Service Bulletin

REFRIGERATOR
MODELS PFSS6, PFSF6 PRODUCED
JULY 2007 THROUGH FEBRUARY 2008
SERIAL NUMBERS: MM070000 to DR079999

REF 02-09

ICE NOT AVAILABLE/NOISY ICEMAKER/NO ICE PRODUCTION

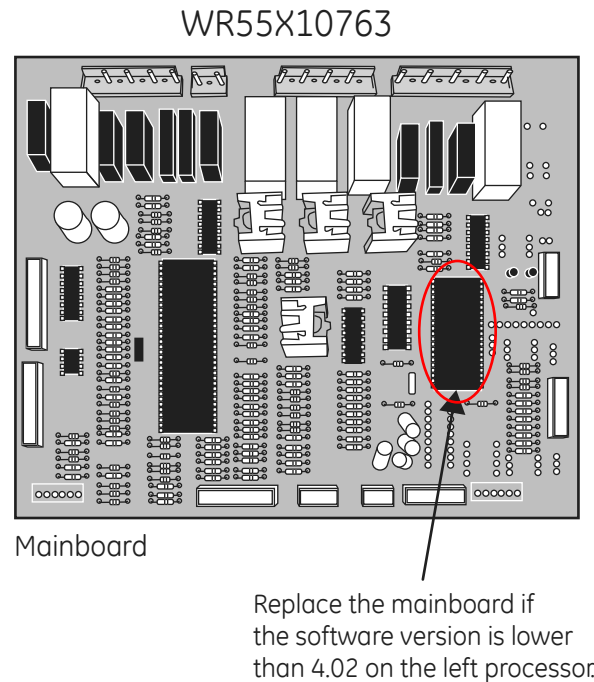
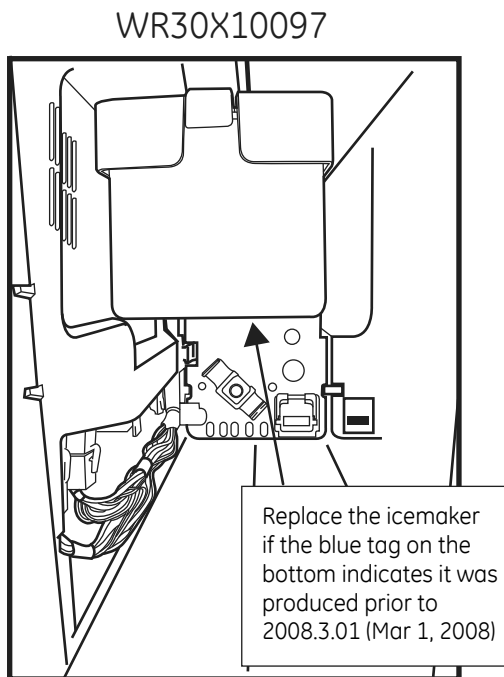
When the icemaker dumps ice cubes to the ice bucket, ice cubes jam between the icemaker and the liner. The icemaker makes a loud noise and eventually stops working.

Replace both the icemaker **WR30X10097** and the mainboard **WR55X10763** if they meet the following criteria:

Replace the icemaker if the blue tag on the bottom indicates it was produced prior to 2008.3.01 (March 1, 2008).

Replace the mainboard if the software version is lower than 4.02 on the left processor.
